## Questions/Comments to LCFS 2023 Amendment

**Name:** Tadashi Ogitsu

**Affiliation:** Lawrence Livermore National Laboratory

Figure 1: Cost breakdown of battery from <https://thundersaidenergy.com/2023/11/18/grid-scale-battery-costs-kw-or-kwh/>

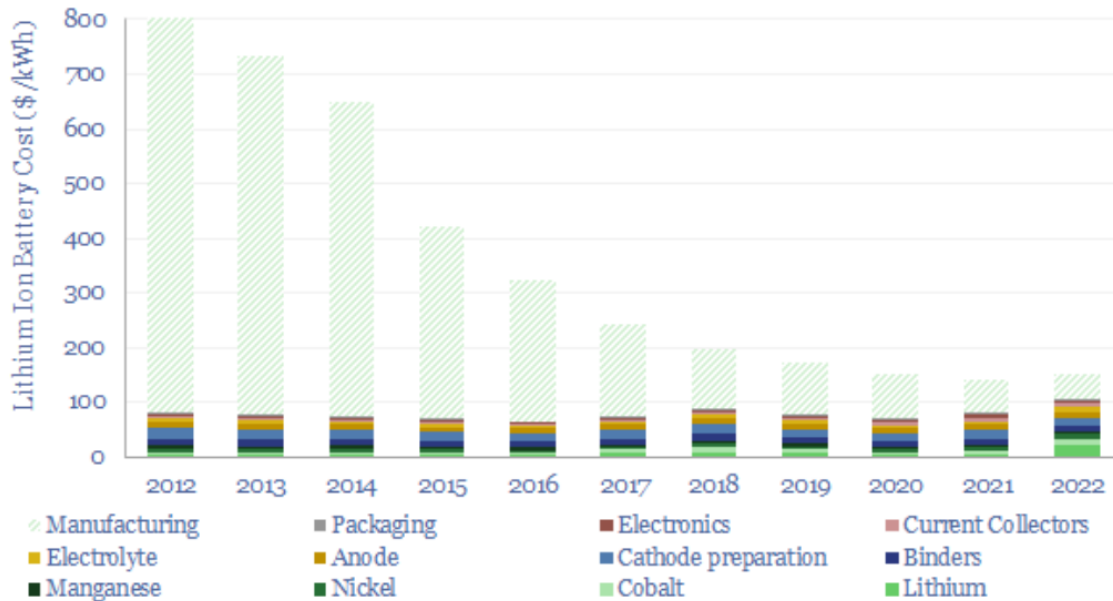
For instance, according to <https://thundersaidenergy.com/2023/11/18/grid-scale-battery-costs-kw-or-kwh/>, recent trend of cost breakdown looks as below. As you can see, manufacturing cost decreased significantly to the point that material cost became dominant. On the other hand, material cost has not come down (as expected). Therefore, I conclude that significant reduction of \$/kWh value of stationary battery is very unlikely to take place.
